August 8, 2008

BELLEFONTE COMBINED LICENSE APPLICATION – RESPONSE TO
ENVIRONMENTAL REPORT REQUEST FOR ADDITIONAL INFORMATION -
HYDROLOGY

ENCLOSURE
RESPONSE TO ENVIRONMENTAL REPORT REQUESTS FOR ADDITIONAL INFORMATION
HYDROLOGY

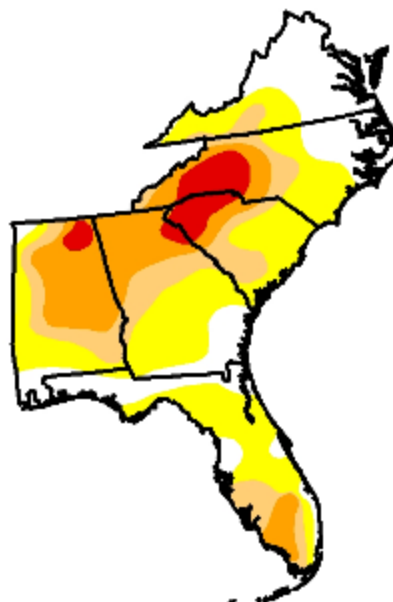
Describe the origin, measurement methods, instrumentation, etc., for the temperature data collected from 1974 to 1990. Provide the data.

The southeastern United States, including northeastern Alabama, has been under moderate to severe summer drought conditions since 2006. Similar drought conditions occurred during the summers of 2000 and 2002 (Attachment 5.2-4C). Temperature data from the WCF encompasses these previous drought years. The highest river temperatures generally occur between mid-July and mid-August. The highest recorded temperature (87.69°F) at WCF, between January 1, 2000 and May 4, 2008 (excluding August 29, 2006 through April 29, 2007 when data were not available) occurred on August 4, 2002 (Attachment 5.2-4D). Comparison to temperatures recorded from the non-drought years of 2003 and 2004 shows summer river temperatures were only 5 to 7°F lower than those recorded during the maximum drought year 2002. Similarly, summer river temperatures during the current drought (since 2006) are generally 1 to 2°F lower than those recorded during the maximum drought year 2002. Therefore, the current and subsequent droughts appear to have a minimal effect on river temperatures, and river temperatures collected previous to the current drought are considered representative of site conditions.

Figure 1 Tennessee River Cross Section Location

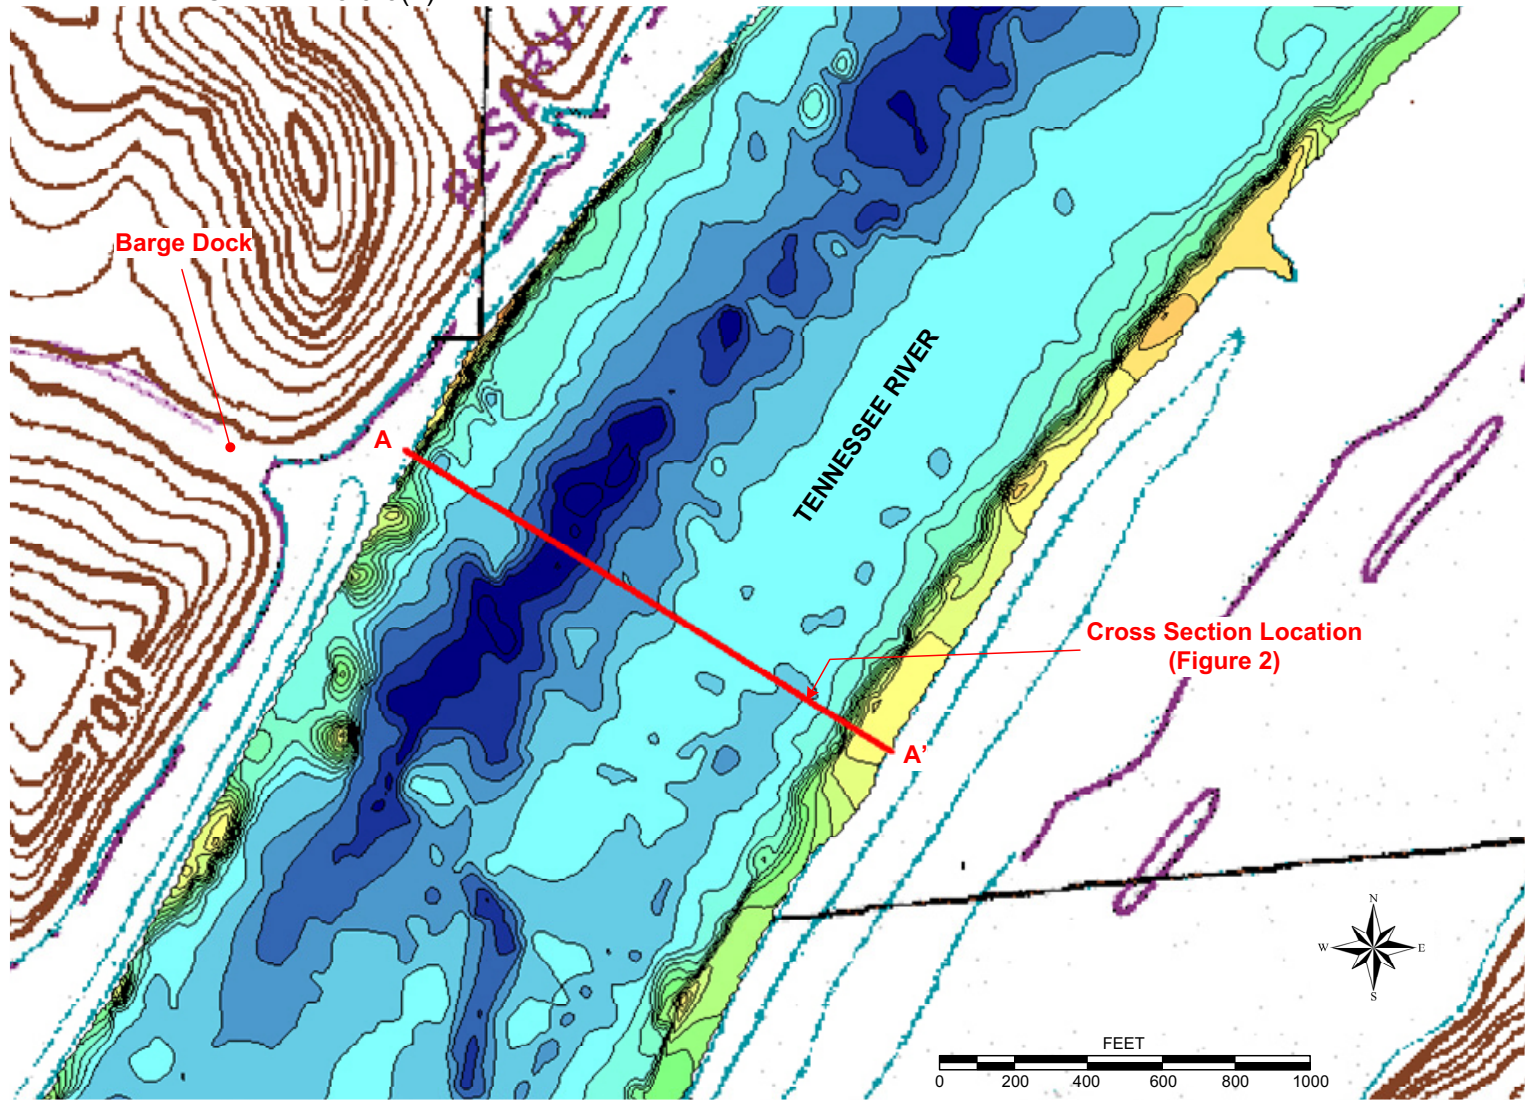
Provide an analysis of the potential for discharge from the diffuser to re-enter the intake canal and be drawn back into the proposed facility. Also analyze the potential for discharge to be drawn into Town Creek.

The discharge diffuser is located approximately 4800 feet downstream (towards Guntersville Dam) of the intake channel inlet and approximately 9400 feet from the confluence of Town Creek and the Tennessee River (Guntersville Reservoir). In order to determine flow velocity of the Guntersville Reservoir, a cross-sectional area of the river channel near the discharge diffuser was developed from the data obtained during the September 2006 bathymetric survey. The location of the cross-section is depicted in Attachment 5.3-3(4)A, and the channel cross-section is shown in Attachment 5.3-3(4)B. The flow velocity (in feet per second) was then calculated by dividing the flow rate (in cubic feet per second [cfs]) by the cross-sectional area (in square feet [ft²]). The flow velocity was calculated for each hour of the reversal and considered as a linear function between hourly data points.
